LONG BEACH CITY COLLEGE DISTRICT
CONTRACTS MANAGEMENT DEPARTMENT

BID C2194 BUILDING MM CONSTRUCTION TRADES 1 MODERNIZATION PROJECT AT THE PACIFIC COAST CAMPUS

ADDENDUM NO # 1

JULY 6, 2020

SHEET NUMBER
C3.10 1

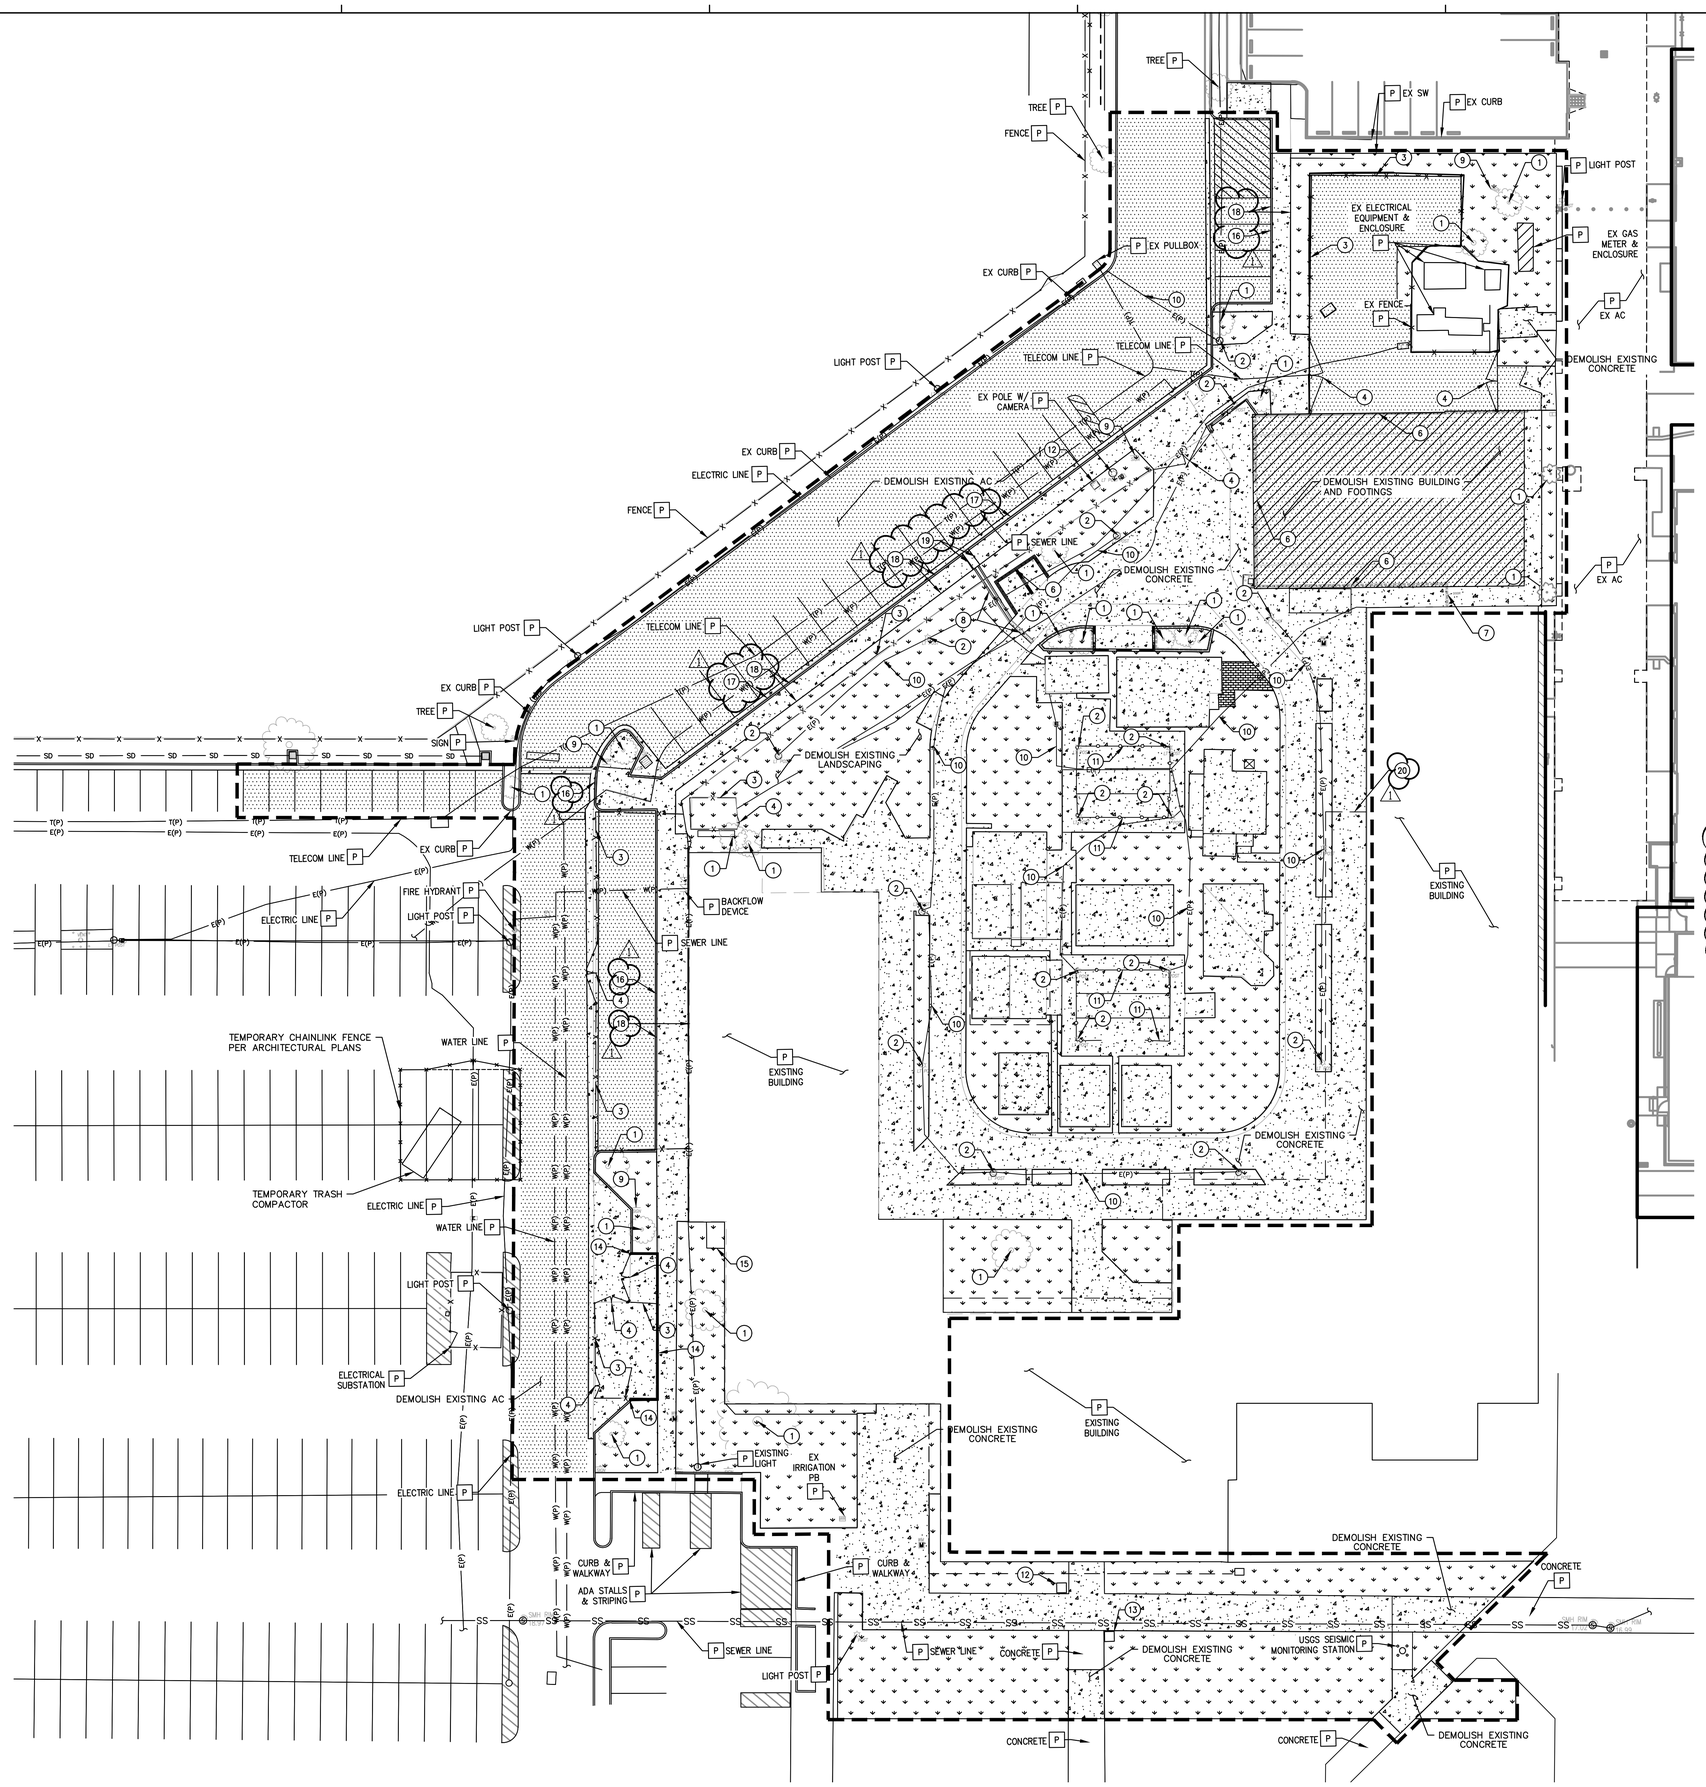
9.	Civil	C3.10	- Provided additional keynotes - Added legend for sawcut. Note that sawcut shall be made at all building faces and paving along the limit of work - Fixed misc. callouts.	Yes

SHEET NUMBER
C4.00

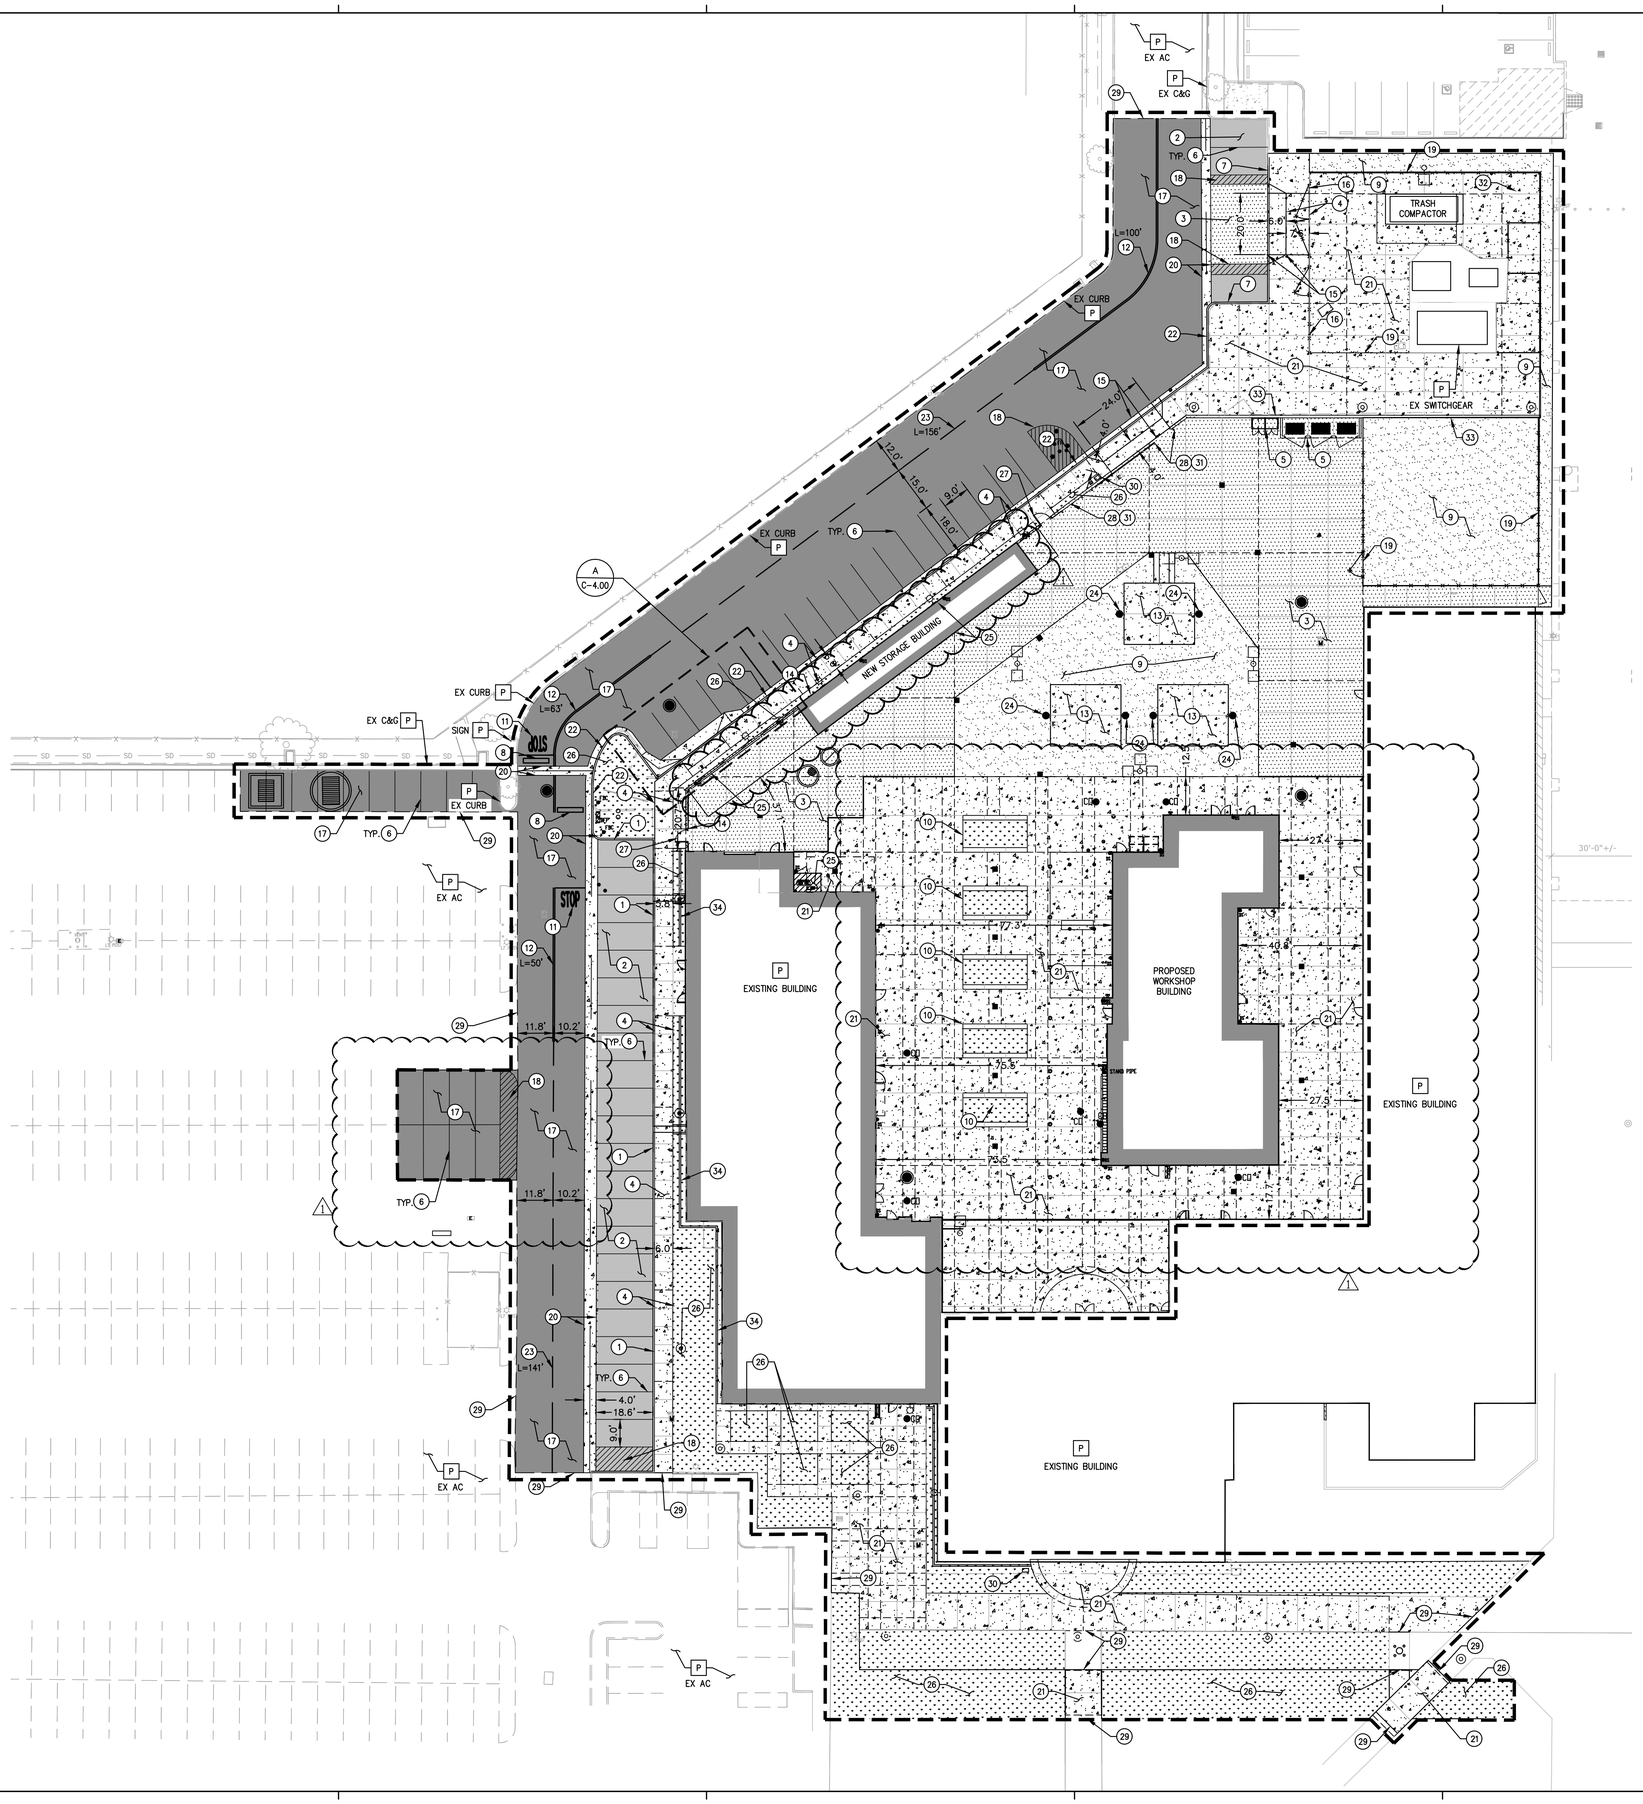
10.	Civil	C4.00	- Area of temp trash compactor added to scope of work. - Fixed and added additional keynotes and dimensions - Provided building location dims - Revised footprint of new storage building.	Yes

SHEET NUMBER
C5.20 1

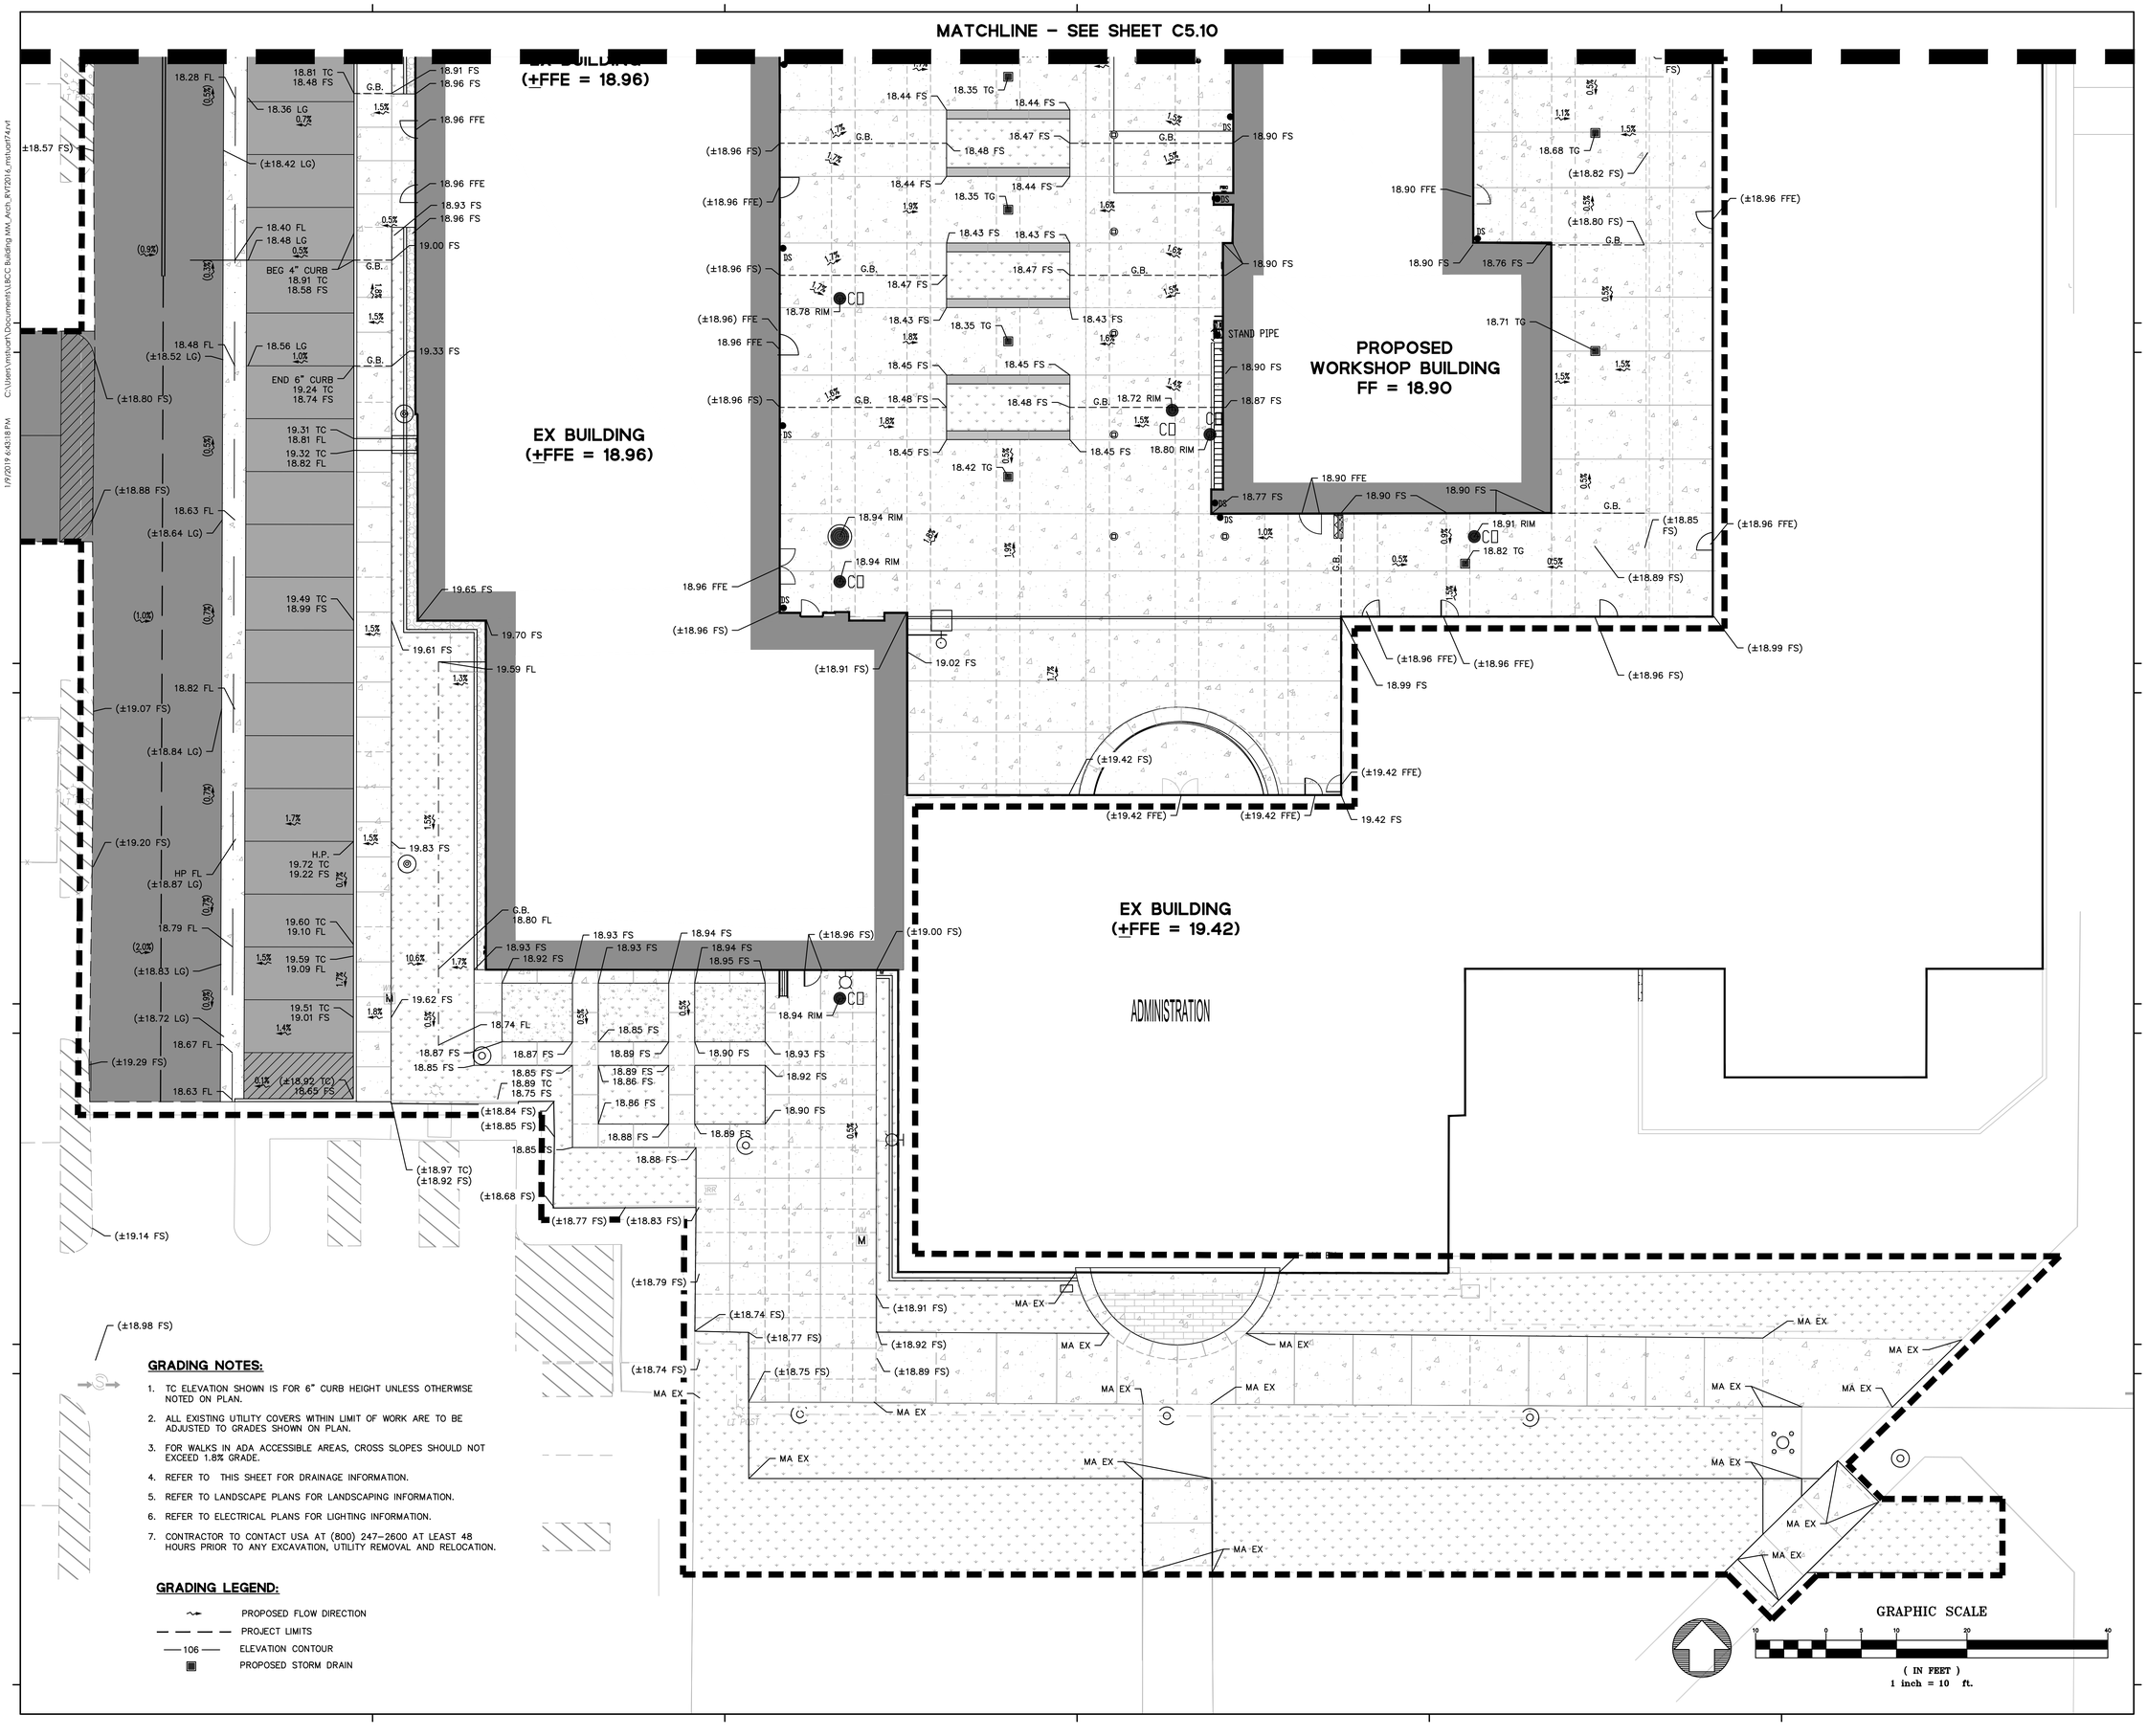
13.	Civil	C5.20	Added and fixed misc. elevations (not clouded for plan clarity)	Yes
14.	Civil	C5.30	Added and fixed misc. elevations.	Yes
15.	Civil	C6.00	- Added downspout locations. - Added and fixed misc. elevations (not clouded for plan clarity) - Coordinated inlets of Contech per C1/C9.10 (not clouded	Yes
